Work Order ID 103529

Item Name: Crosstube Assembly, Mid Aft

DART AEROSPACE LTD HAWKESBURY, ONTARIO, CANADA	
DRAWING NO. D206-667-247	REV. A SHEET 1 OF 4
TITLE CROSSTUBE ASS'Y (206L MID AFT)	SCALE NTS
COPYRIGHT © 2010 BY DART AEROSPACE LTD THIS DOCUMENT IS PROPRIETARY AND CONFIDENTIAL AND IS SUPPLIED IN THE EXPRESS CONDITION THAT IT IS NOT TO BE USED FOR ANY PURPOSES OR COPIED OR COMMUNICATED TO ANY OTHER PERSON WITHOUT WRITTEN PERMISSION FROM DART AEROSPACE LTD

DRAWING NO. D206-667-247	TITLE CROSSTUBE ASS'Y (206L MID AFT)	REV. A	DART AEROSPACE LTD ENGINEERING ORDER		D.E.O. NO. D206-667-247-A-1	SHEET NO. SHEET 1 OF 1	SCALE NTS
DRAWN 92	CHECKED ASS	MFG. APPR. KJ	APPROVED JMD		DE APPR. H		
DATE 11.07.15	DATE 11.07.20	DATE 11.07.21	DATE 11/07/21		DATE 11.07.21

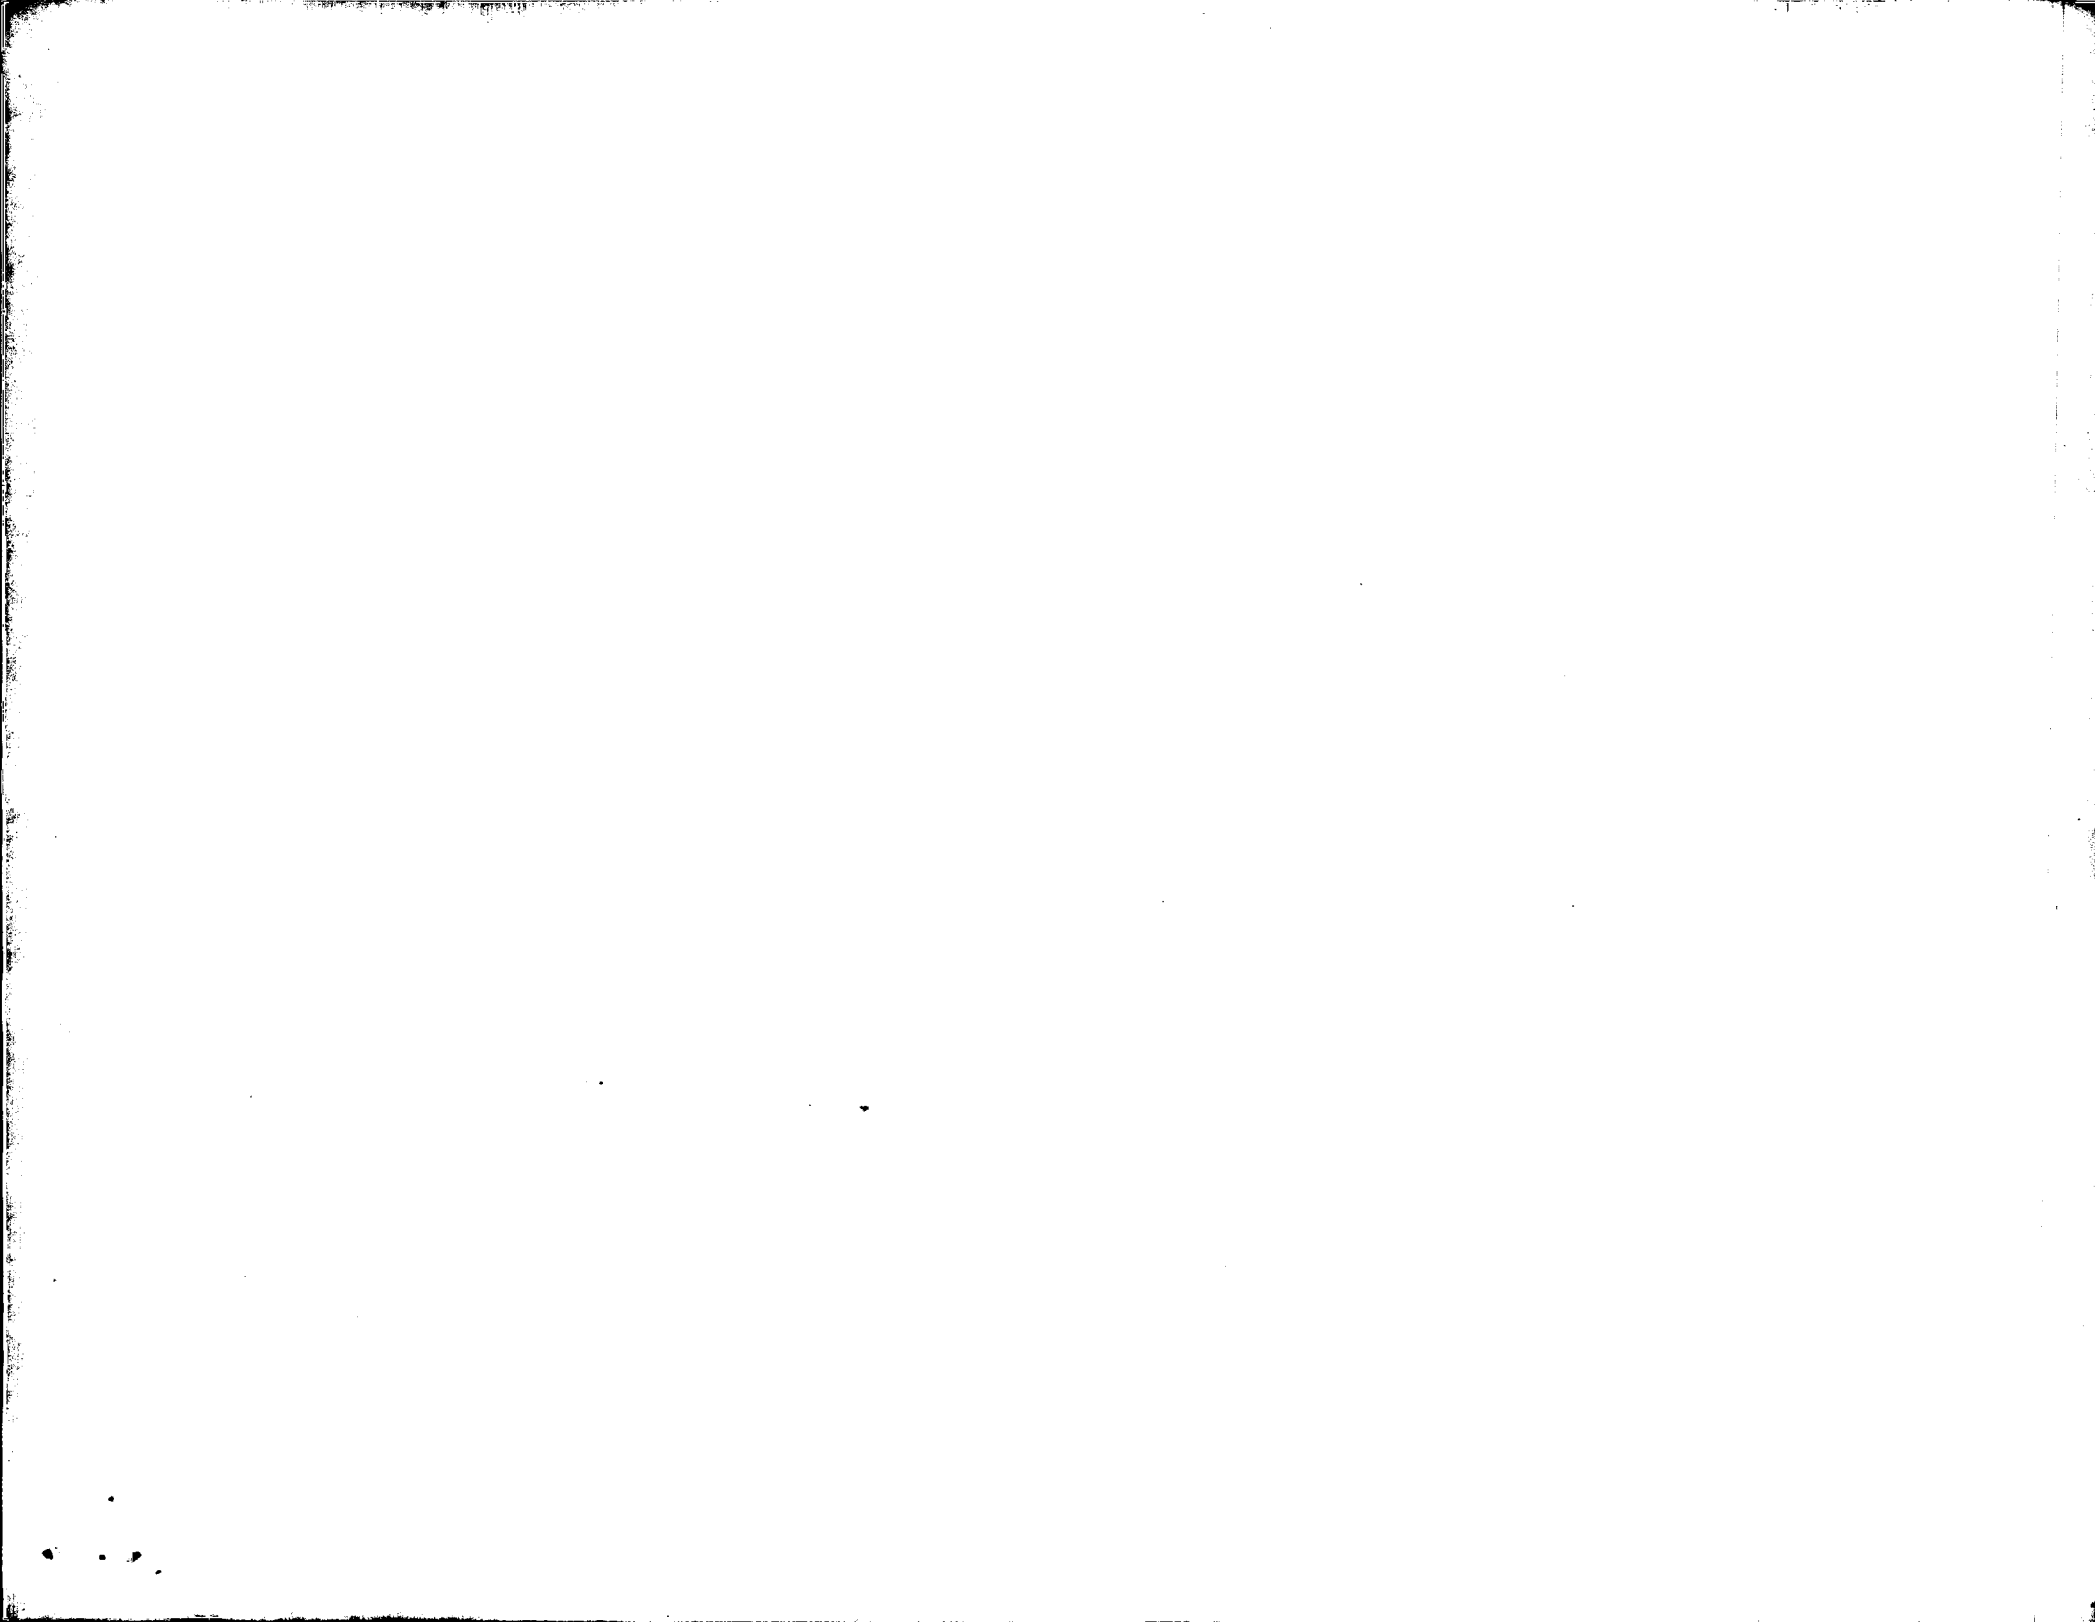
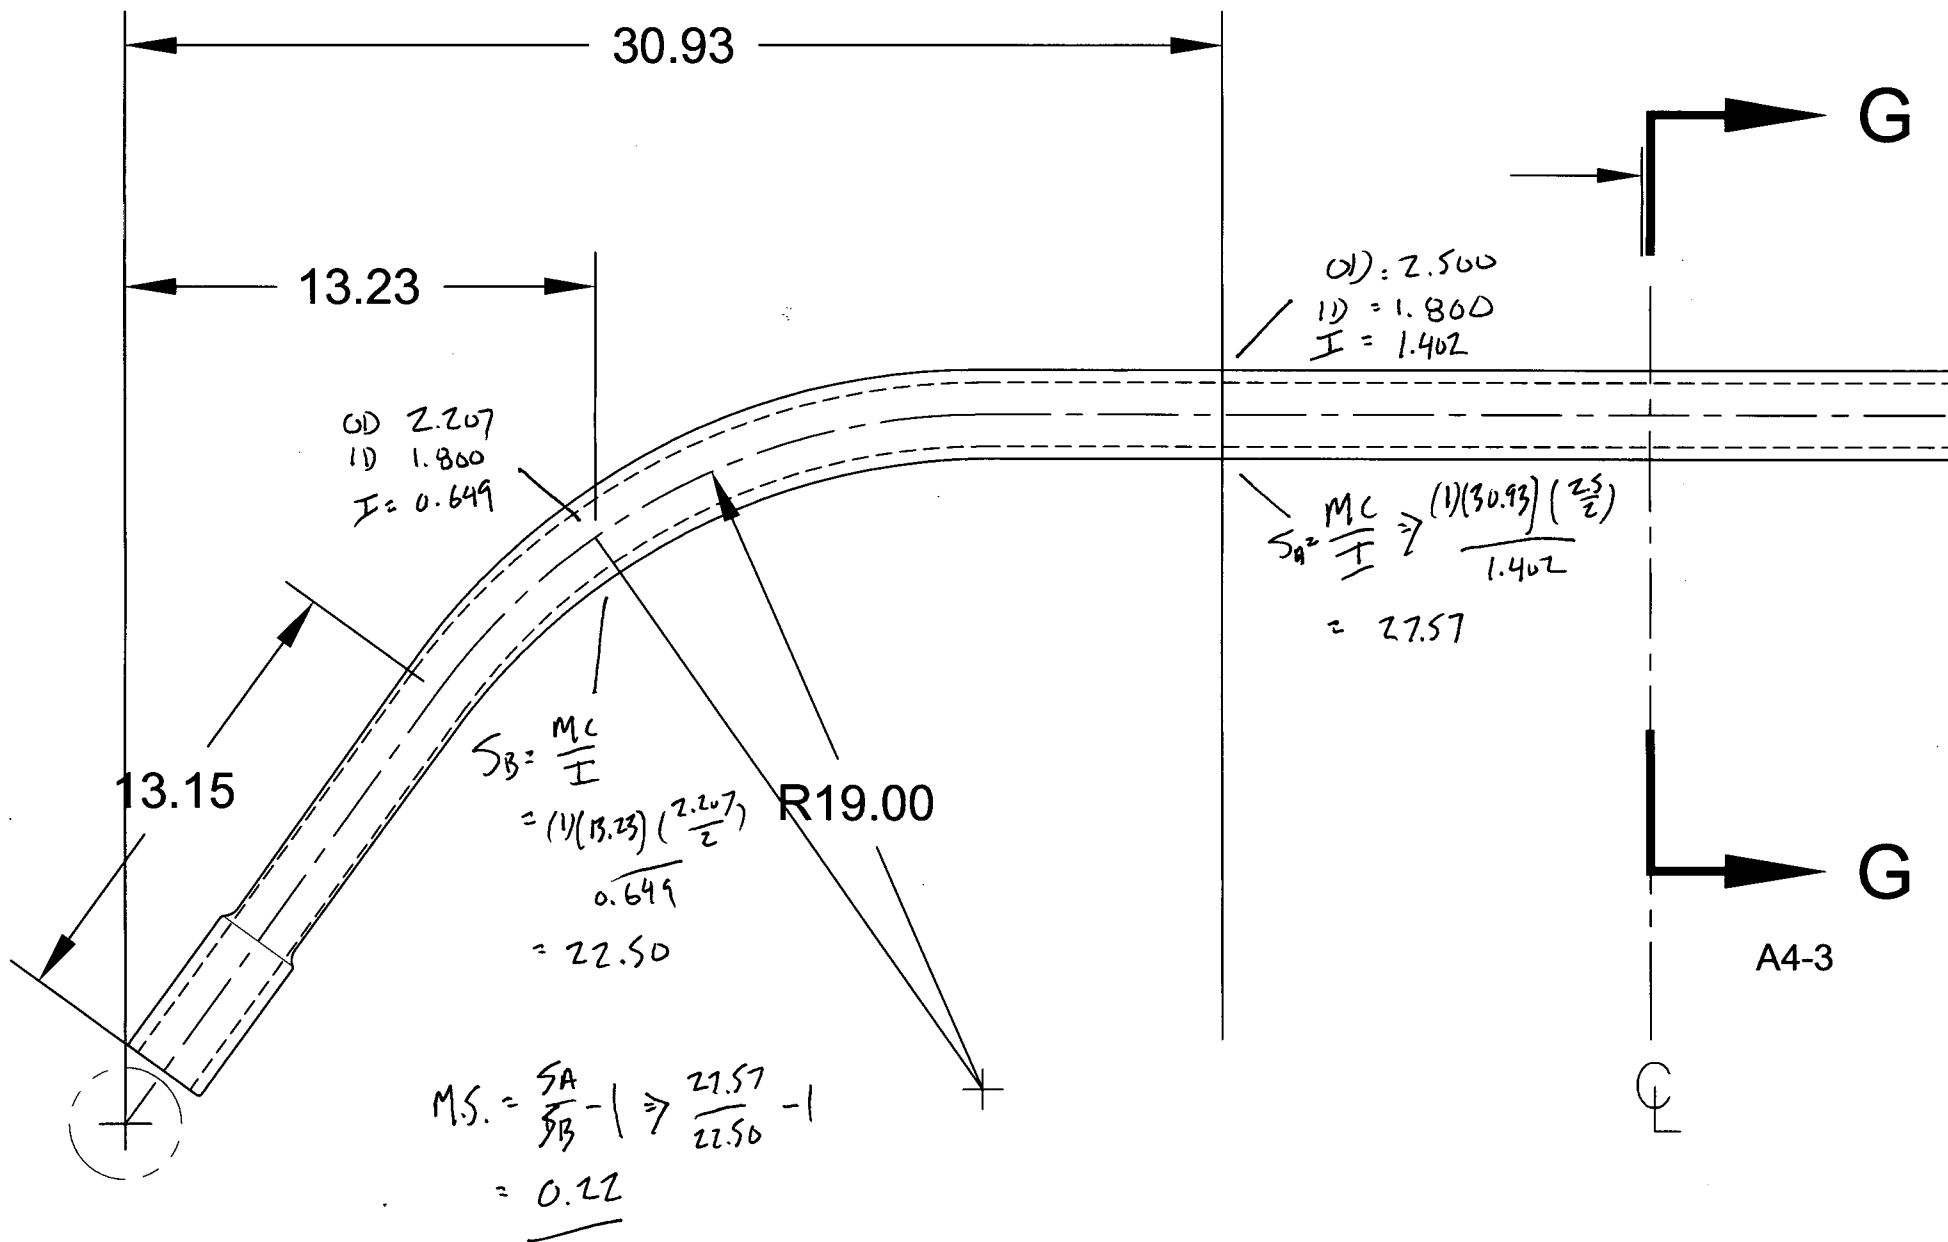
PURPOSE:

REPLACE MAGNOBOND WITH PROSEAL.

Item	Qty -247	Part Number	Description
9	A/R	PROSEAL 890 B-2	SEALANT, AMS-S-8802 CLASS B-2

9	A/R	MAGNOBOND 6398	ROCKWELL SPECIFICATION RBO-120-023 ADHESIVE (TEXTRON/BELL SPEC. 299-947-100, TYPE II, CLASS 2 ADHESIVE)
---	-----	----------------	---

NOTE 12 & 15, SHEET 1 IS AMENDED AS FOLLOWS:

- 12) TO INSTALL D2892-1 SUPPORT: ABRASE MATING SURFACE OF SUPPORT AND CROSSTUBE WITH 180-GRIT SANDPAPER AND REMOVE RESIDUE WITH MEK (OR EQUIVALENT). APPLY A 0.04" TO 0.07" THICK LAYER OF PROSEAL 890 CLASS B-2 (OR AMS-S-8802 CLASS B-2) SEALANT TO MATING SURFACE OF SUPPORT.
- 15) TORQUE CLAMPS 80 TO 100 IN-LB. ENSURE AT LEAST 1.5 THREADS SHOWING IN SAFETY AND THAT NUT HAS NOT BOTTOMED-OUT AFTER TORQUING. **PRIOR TO PACKAGING, RE-CHECK TORQUE ON CLAMPS AFTER PROSEAL 890 SEALANT HAS CURED FOR 72 HOURS.**

- 12) INSTALL D2892-1 SUPPORT USING 0.03" TO 0.06" THICK LAYER OF MAGNOBOND 6398 PER QSI 015. LET CURE FOR 12 HOURS AFTER INSTALLATION AND PRIOR TO PACKAGING.
- 15) TORQUE CLAMPS 80 TO 100 IN-LB. ENSURE AT LEAST 1.5 THREADS SHOWING IN SAFETY AND THAT NUT HAS NOT BOTTOMED-OUT AFTER TORQUING.
